Carbonated Fly Ash Brick (C-Brick) Plant of 2 Lakh per Day Capacity at NTPC Ramagundam

Bidding Document No: CS-3100-702-9 GEPNIC Tender Ref. No: 2025_NTPC_98848_1

Amendment No 01 to Technical Specification (Section-VI)

PROPOSED AREA FOR C-BRICK PLANT

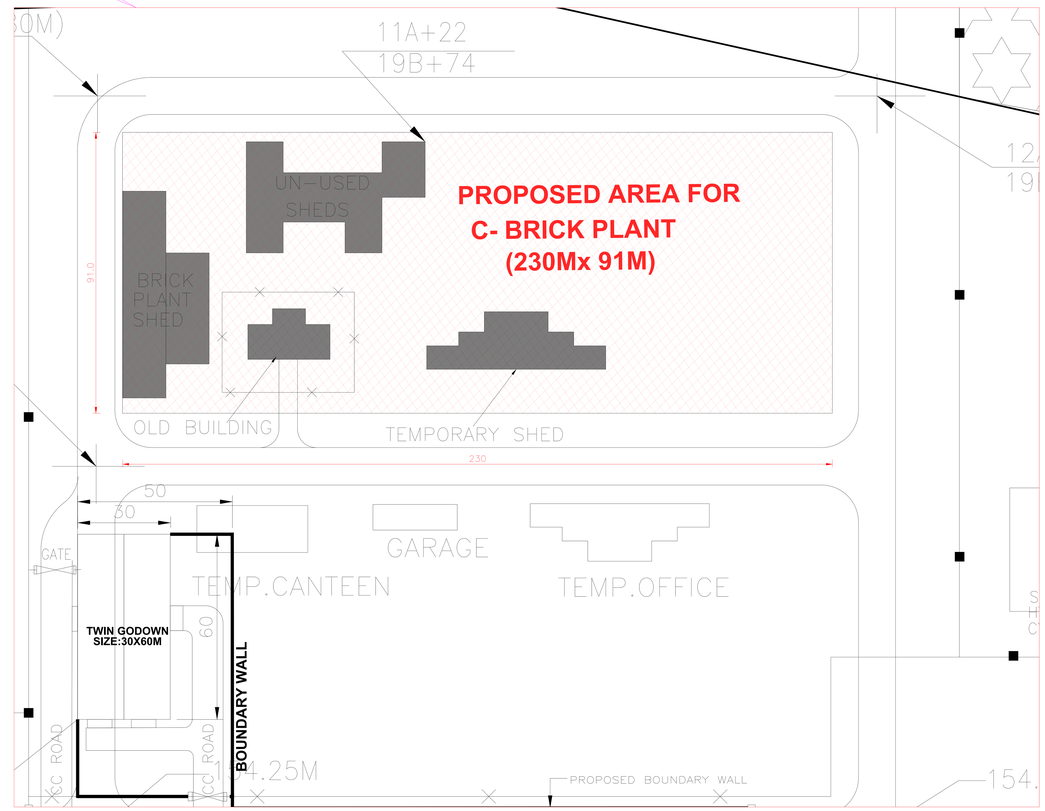
3	Section-VI	A- Project Information	(Page 3 of 115)	A3: Scope of Work: Clause No 8	As required and with express approval of NTPC, dismantling / demolition of existing structure at site earmarked as Area-A (CO2 Capture, Compression, and Storage Block and Area-B (C-Brick Manufacturing Block) alongside area clearance, transport and handing over of dismantled material to NTPC (within plant premises), site levelling and grading, cleaning of vegetation (including statutory clearance, if required) shall be in the scope of bidder.	As required and with express approval of NTPC, dismantling / demolition of existing structure **including substructure** at site earmarked as Area-A (CO2 Capture, Compression, and Storage Block and Area-B (C-Brick Manufacturing Block) alongside area clearance, transport and handing over of dismantled material to NTPC (within plant premises), site levelling and grading, cleaning of vegetation (including statutory clearance, if required) shall be in the scope of bidder.

NOTE:
EXISTING BRICK PLANT AND EXISTING SHEDS AS TO BE DISMANTLED.
